Access Compliance Report

Public Rights-of-Way

Intersection ID: 52457	Main Street: ORCHARD_LAKE_DR	Cross Street: LUCY_JANE_LN	Location:	W
ADA ID: 3E2DA943467B	Ramp Type: BlendTrans1	Initial Pass/Fail: Pass	Overall Compliance: No	Severity Score: 0.25

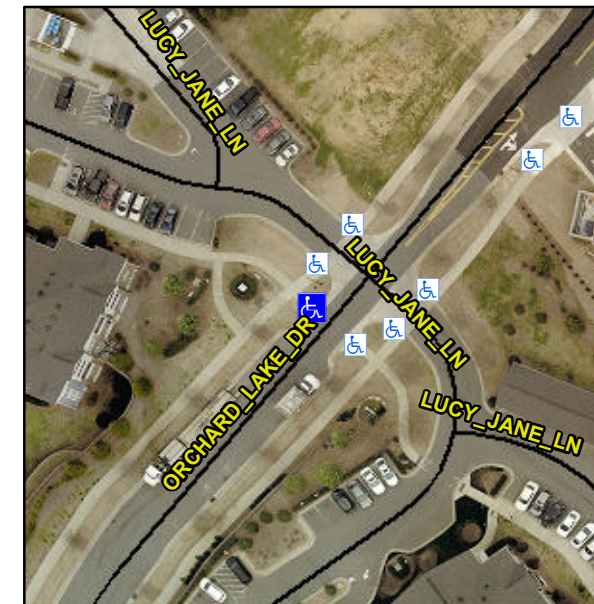
Not Found, R304.5.3, R304.2.1

Compliance	Description	Data	Compliance	Description	Data
N/A	Ramp Length (in)	60.0	Yes	BlendTrans Slope (%)	4.0
Yes	Ramp Width (in)	61.0	No	BlendTrans XSlope (%)	2.2
N/A	Flare Type LT	Sloped	N/A	Flare Type RT	Sloped
N/A	Flare Slope LT (%)	5.0	N/A	Flare Slope RT (%)	6.4
N/A	Flare Traversable LT?	No	N/A	Flare Traversable RT?	No
No	Landing Length (in)	46.0	Yes	DWS Provided?	Yes
Yes	Landing Width (in)	61.0	Yes	DWS Contrast?	Yes
Yes	Landing Slope (%)	1.1	Yes	DWS Length (in)	24.0
Yes	Landing X Slope (%)	1.5	Yes	DWS Full Width?	Yes
N/A	Landing Curb? (Y/N)	No	Yes	DWS Offset (in)	1.0
N/A	Shared Landing?	No			
Yes	Gutter Ponding?	No	Yes	Gutter Slope (%)	3.9
Yes	Gutter Lip Ht (in)	0.0	Yes	Gutter X Slope (%)	0.9
N/A	Painted X Walk1?	No	N/A	Painted X Walk2?	N/A
	X Walk 1 Direction	To SE		X Walk 2 Direction	N/A
	X Walk 1 Width (in)	N/A		X Walk 2 Width (in)	N/A
	X Walk 1 Slope (%)	0.3		X Walk 2 Slope (%)	N/A
	X Walk 1 X Slope (%)	0.4		X Walk 2 X Slope (%)	N/A

Remove & Replace Curb Ramp With Two New Directional Ramps or Equivalent.
